City of Bend Standards and Specification Summary of 2024 Revisions

Revisions in this notice will be effective **November 1, 2024**

Provided below is a summary of the draft revisions to the **City of Bend Standards and Specifications**, adopted April 15, 2022. Text in **red** is a revision to the standard drawing.

BIO BAG INLET PROTECTION

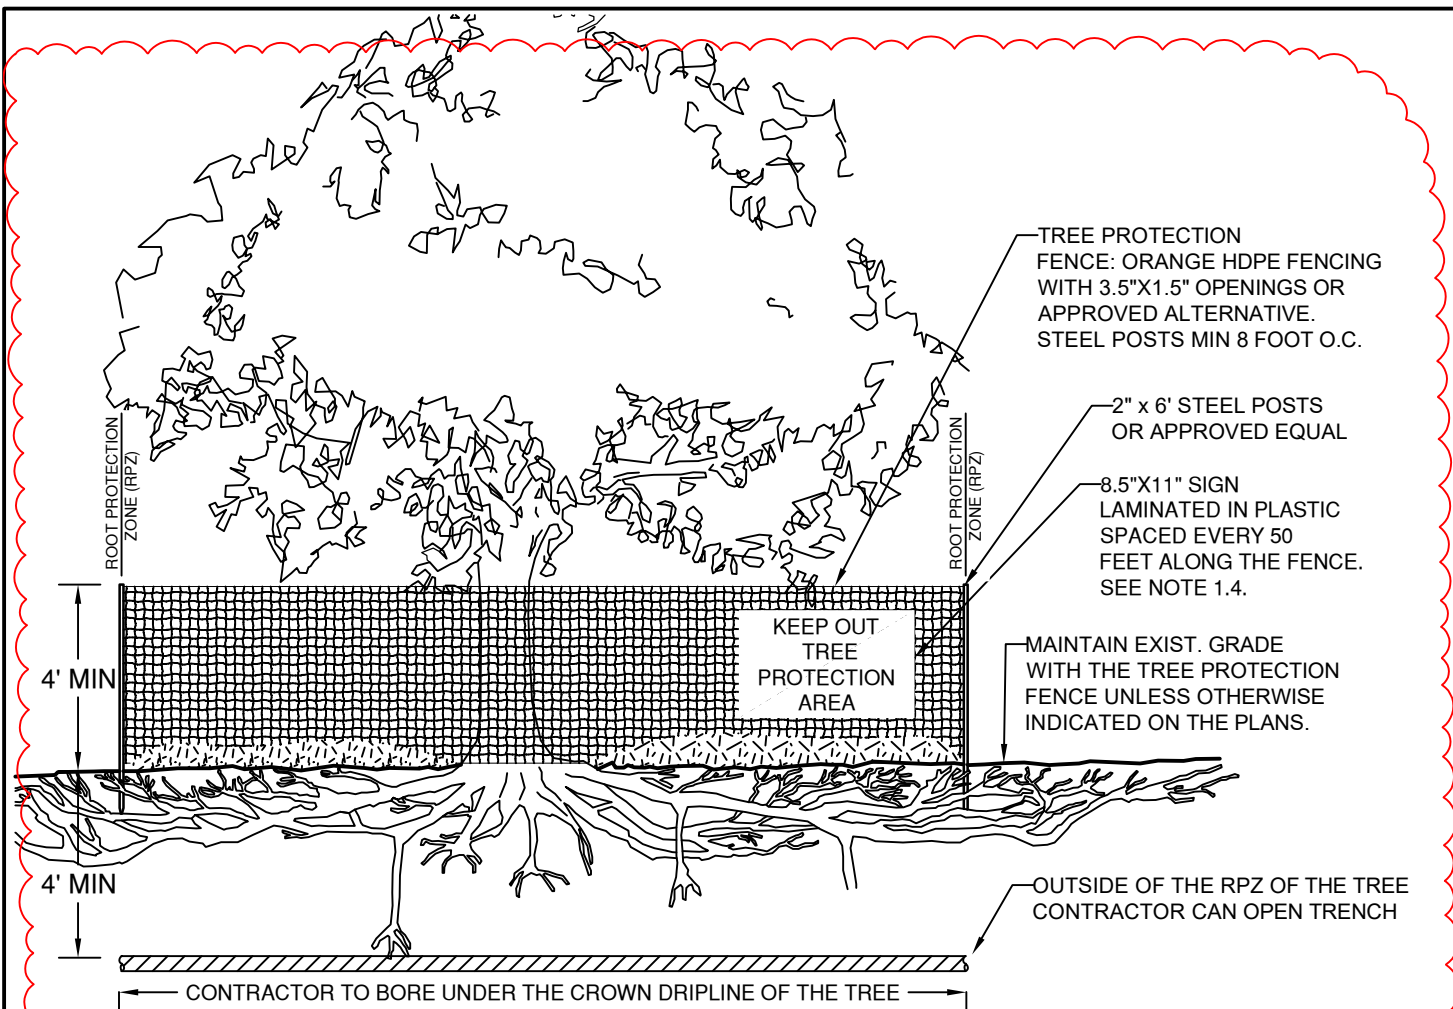
~~Inlet protection placed on grated inlets of street surfaces (bio-bags, gravel bags, bales, etc.) will not be permitted. All grated inlets are required to have pre-fabricated filter inserts with overflow installed per Standard Drawing E-2B. Field fabricated inserts (filter fabric, drain cloth, etc.) are not permitted.~~

DRAWN CJH			CITY OF BEND	CITY OF BEND STANDARD DRAWING 710 NW WALL ST., BEND, OREGON 97701	SCALE NTS
BY EROSION					DATE 11/01/2024
REV	DATE				APPR
					STD DWG E-3
				TREE/VEGETATION PROTECTION FENCING

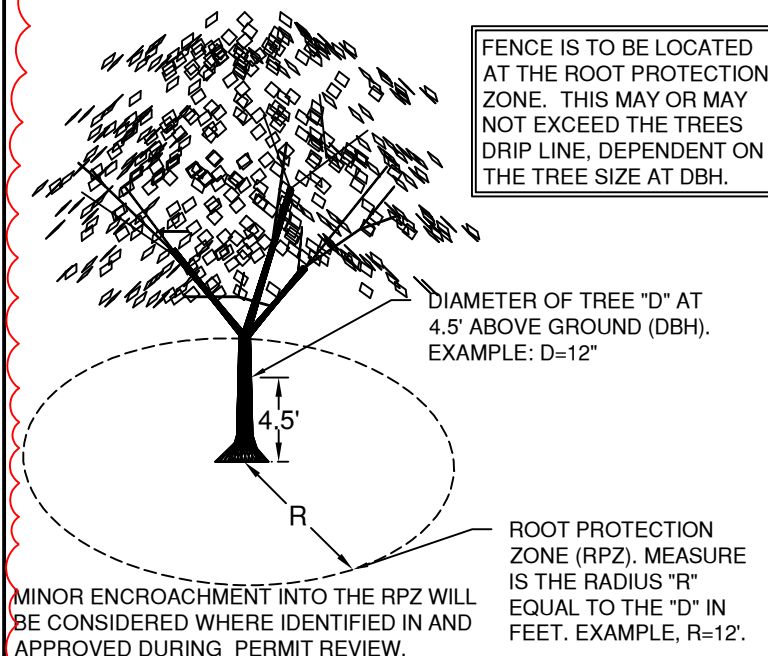
- Existing vegetation areas that will remain as-is including existing turf areas.
- Proposed protection fencing locations and type of protective measures in compliance with Standard Drawing E-3, Tree/Vegetation Protection Fencing.

CLEAR VISION AREAS AT INTERSECTIONS

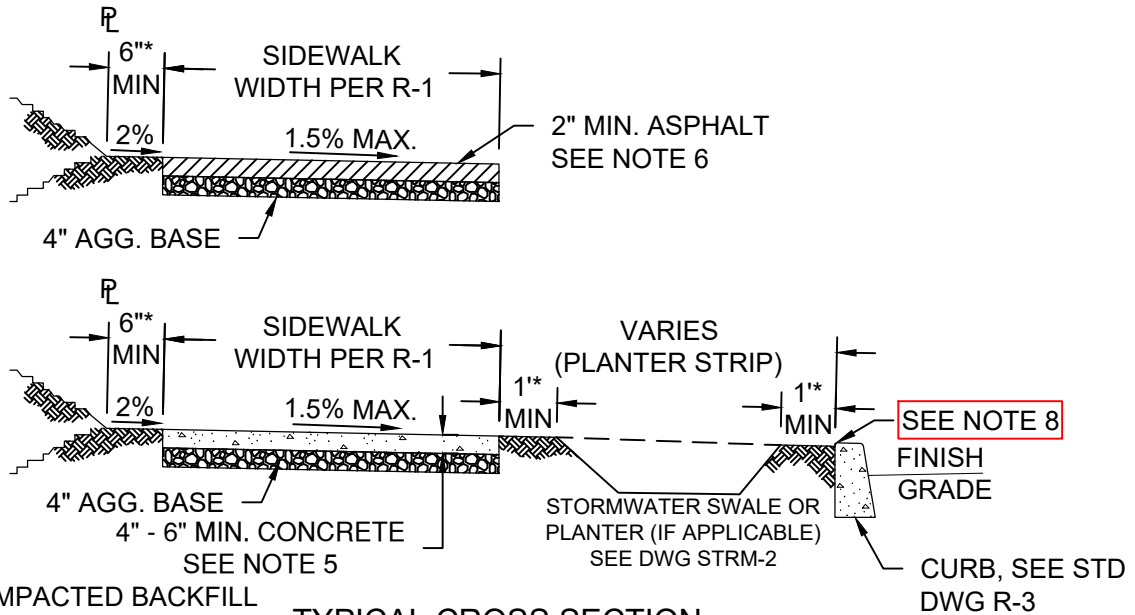
Plants that will attain a mature height of two feet or more in height ~~must~~should not be planted in Clear Vision Areas, Intersection Sight Triangles, nor Sight Distance Areas. Refer to Standard Drawing R-2 and 3.3.4.3 - Intersection Sight Distance vs. Clear Vision Area. The height of the plant ~~shall~~must include the ~~adjacent~~abutting curb height and any earthwork or grading within the plant bed.

DRAWN CJH		CITY OF BEND STANDARD DRAWING 710 NW WALL ST., BEND, OREGON 97701	SCALE NTS
DIV ROADWAY			DATE 11/01/2024
REV DATE			APPR
		FRANCHISE UTILITY JOINT TRENCH	STD DWG R-10A

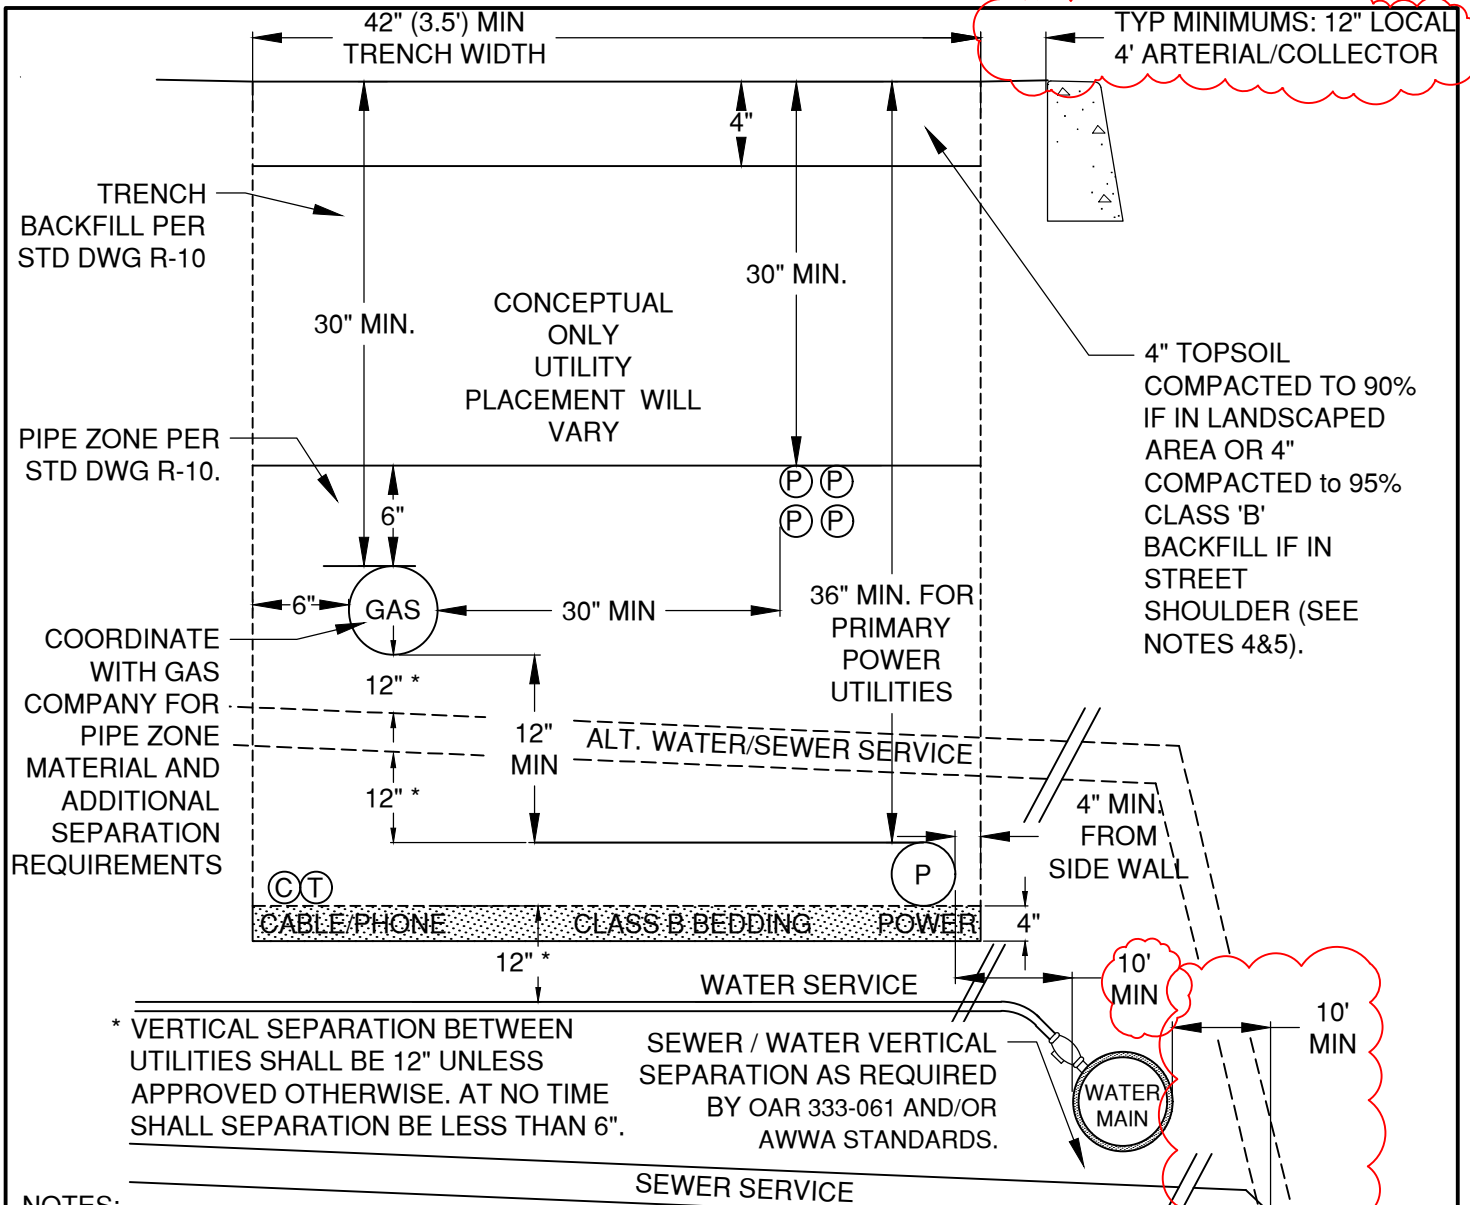
* VERTICAL SEPARATION BETWEEN UTILITIES SHALL BE 12" UNLESS APPROVED OTHERWISE. AT NO TIME SHALL SEPARATION BE LESS THAN 6".

TYPICAL 2" SERVICE WITH 1-1/2" AND 2" METER

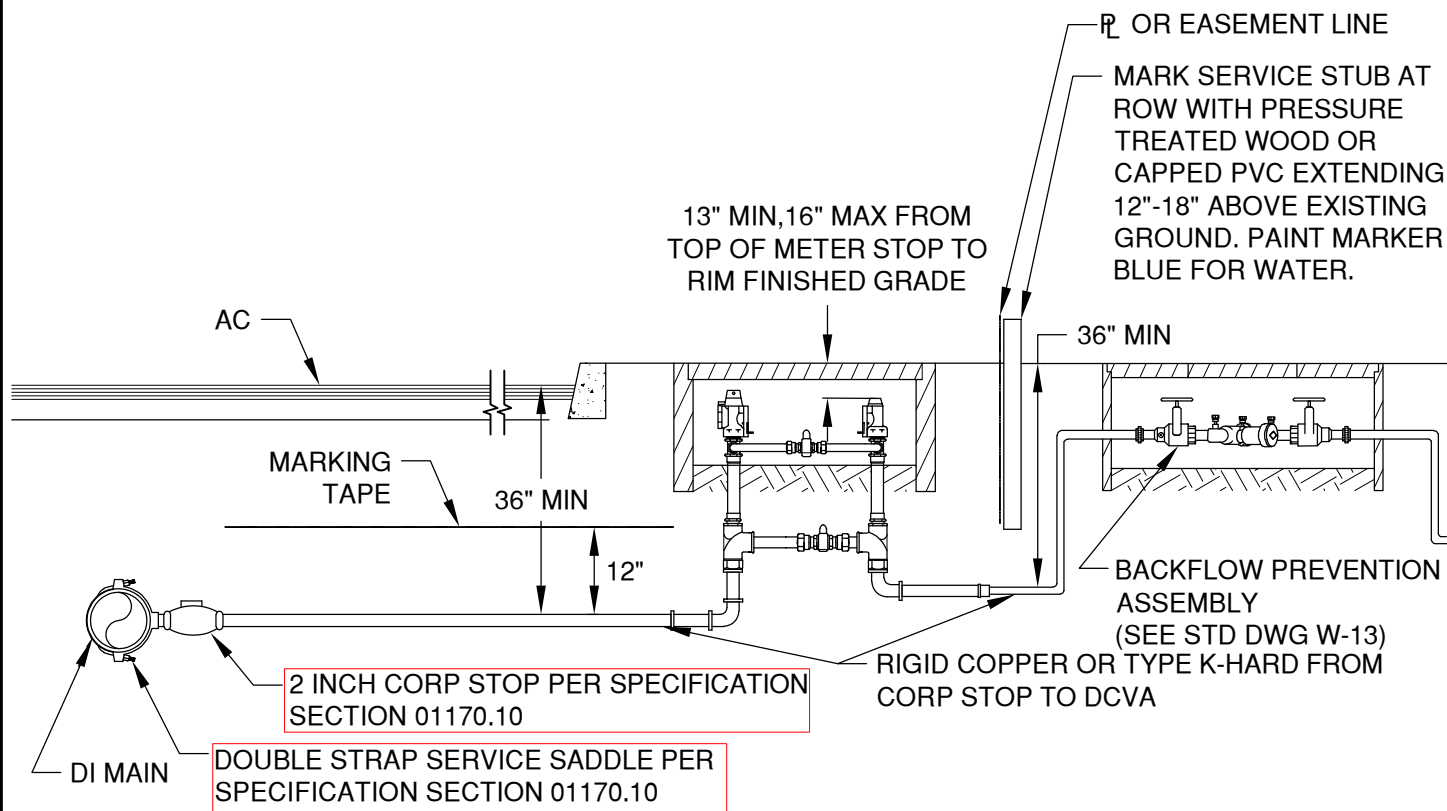
(d) **Meter Setters** - All 1.5- to 2-inch meters shall use a ~~meter setter series # B-2423-99000 with a 12-inch setter height as shown in Standard Drawing W-5A~~ 2-inch meter setter with a 12-inch height, 17-inch meter spacing, high bypass ball valve with padlock wing, meter support brackets and flanged angle ball valve with padlock wings as manufactures by Mueller, A.Y. McDonald, Ford Meter Box, or approved equal.
